BODY ELECTRICAL

FUSE

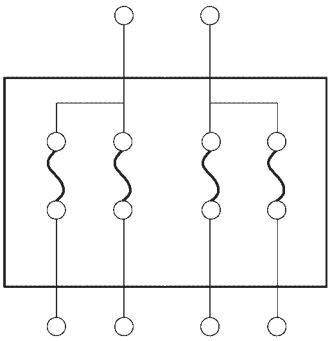
Because a single fuse was used on the previous model for supplying power to multiple systems, one blown fuse affected the operation of numerous systems. For this reason, the new model has adopted a multi-fuse system in which a single fuse housing contains four fuses. Four of these fuses are used in the junction block located in the vehicle interior.
